NO.	DATE	DESCRIPTION	BY	APP.
1	8/17/18	PCO #6 Natoma Extension	ST	SL

2ND STREET STREETSCAPE IMPROVEMENTS PROJECT

STREET LIGHTING PLAN
NATOMA STREET, 2ND ST TO TRANSBAY TERMINAL

CONTRACT NO. 1064J
DRAWING NO. NE-1
FILE NO. 140,267.1
REV. NO. 1

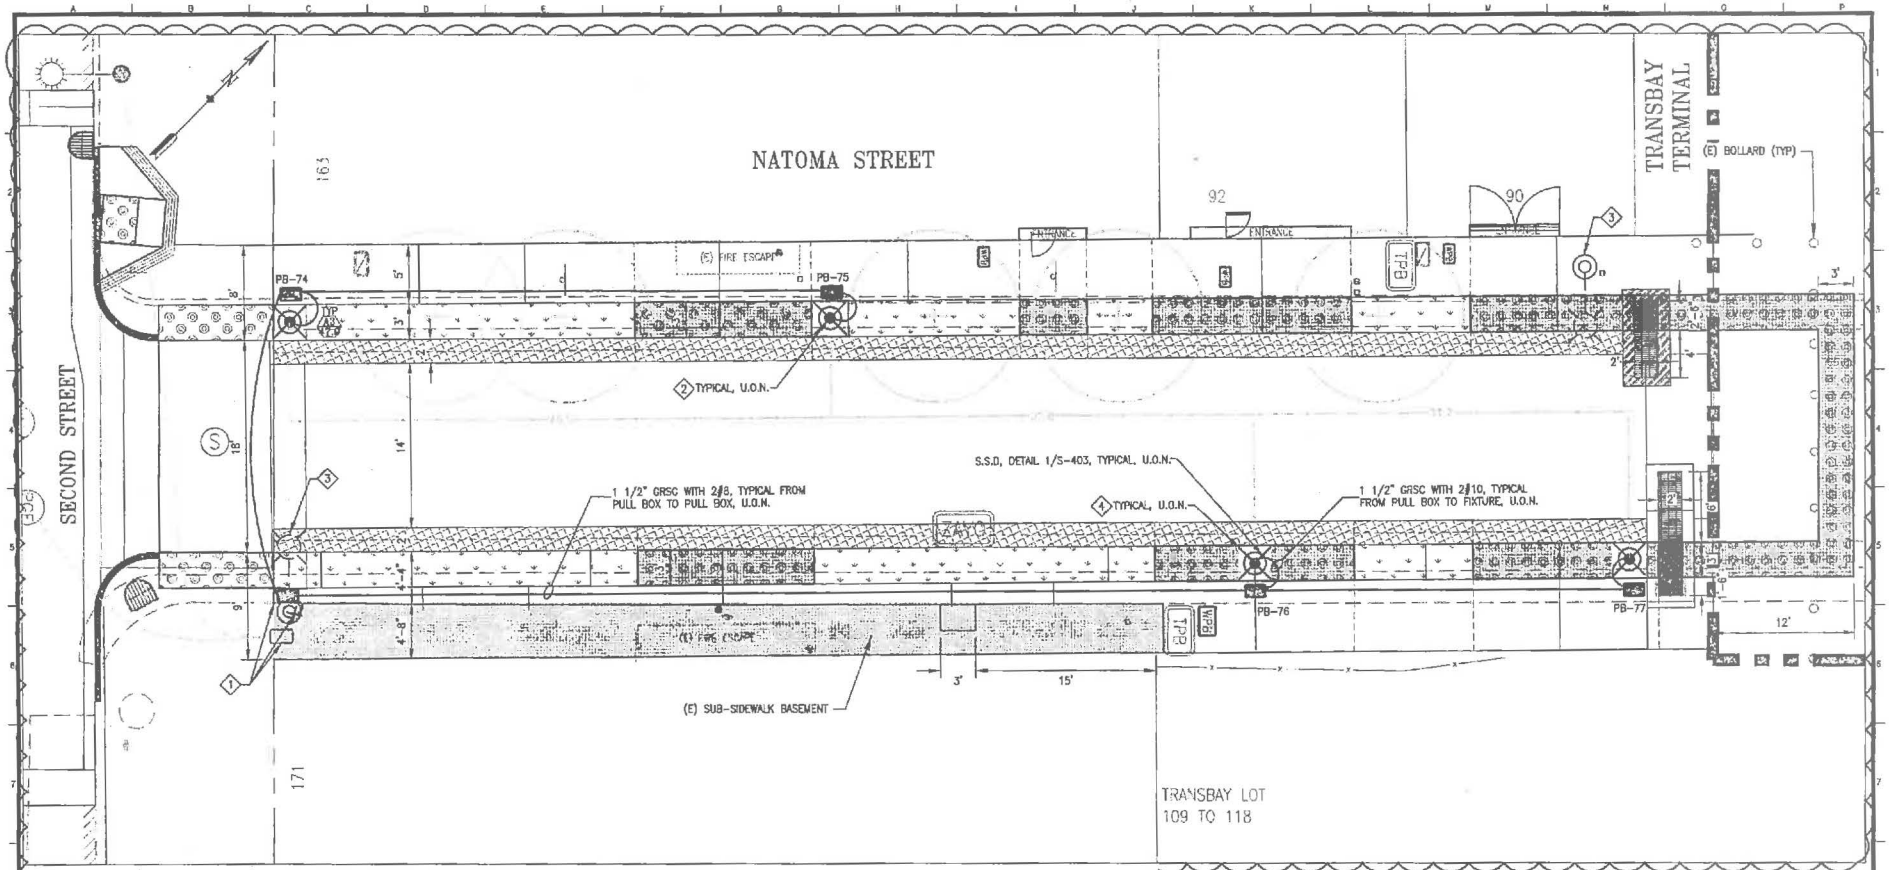
1. INTERCEPT EXISTING STREETLIGHT CONDUIT WITH A TYPE I PULL BOX ON SIDEWALK SURFACE. SPLICE NEW WIRES AND EXISTING WIRES IN EXISTING SUB-SIDEWALK BASEMENT PULL BOX.
2. PROVIDE 10A FUSE AND FUSE HOLDER FOR NEW PEDESTRIAN LIGHTS.
3. R/C STREET LIGHT POLE, ARM AND FIXTURE.
4. DETECTABLE SURFACE TILES SHALL BE OFFSET FROM OUTER EDGE OF ANCHOR BOLTS BY 6-INCHES. THE SIDEWALK AND STREET SIDE OF THE LIGHT SHALL HAVE NO DETECTABLE SURFACE TILES.
